ST**M** 24.06.24

FIRST FLOOR SOFFIT AND GRC COLUMN CLADDING

SHOP DRAWING
TYPICAL COLUMN GRC CLADDING DETAIL

Dwg No: 63068-WSN-ZZ-ZZ-DR-Y-3211 Rev: C02

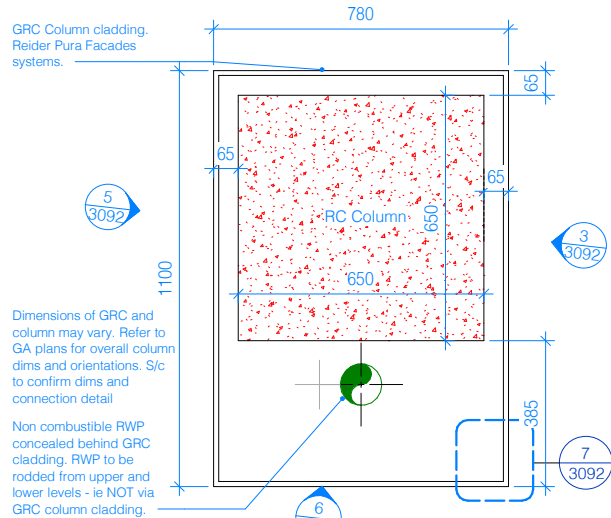
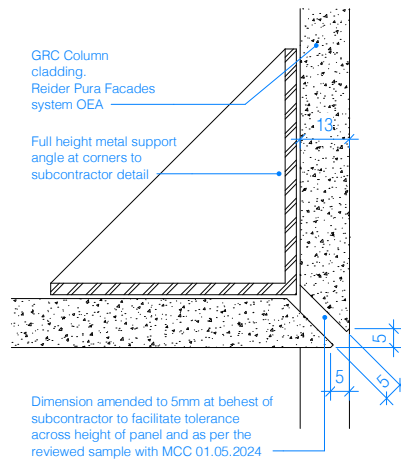
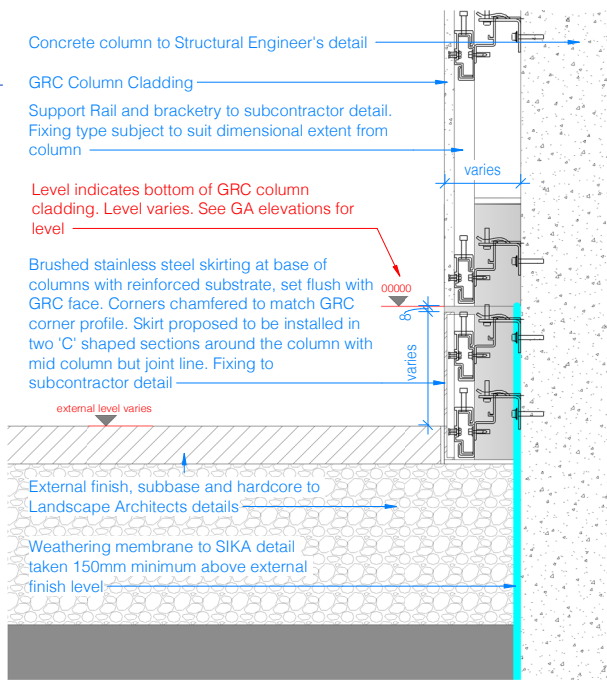
OVERALL LENGTH IS LONGER THAN
PROPOSED BUT ACCEPTED ON
BASIS THAT THE FRONT EDGE
REMAINS ALIGNED WITH JUNCTION
WITH SOFFIT.

ANGLED BRACKET AT ALL 4 NO.
CORNERS EXTENDS FULL HEIGHT
AND A HORIZONTAL COVER PLATE AT
THE CORNER TO MITIGATE VIEW S
INTO THE SYSTEM

HOD 25.04.24
STATUS B

FIGURE 1

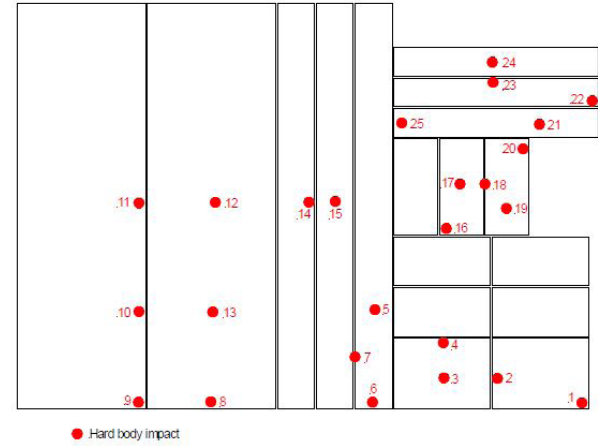
In accordance with CWTC TN76 Standard the proposed GRC product test data shows that the product obtains:

Class 1 / Negligible risk
(see extract opposite)

Junction at the corners

The corner detail can product vary and is not covered in the CWTC test data.

An additional aluminium angle has been introduced to support the corner detail and tighten the gap between the panels.

The sharp arrises of the birds mouth detail are proposed with a slight chamfer.
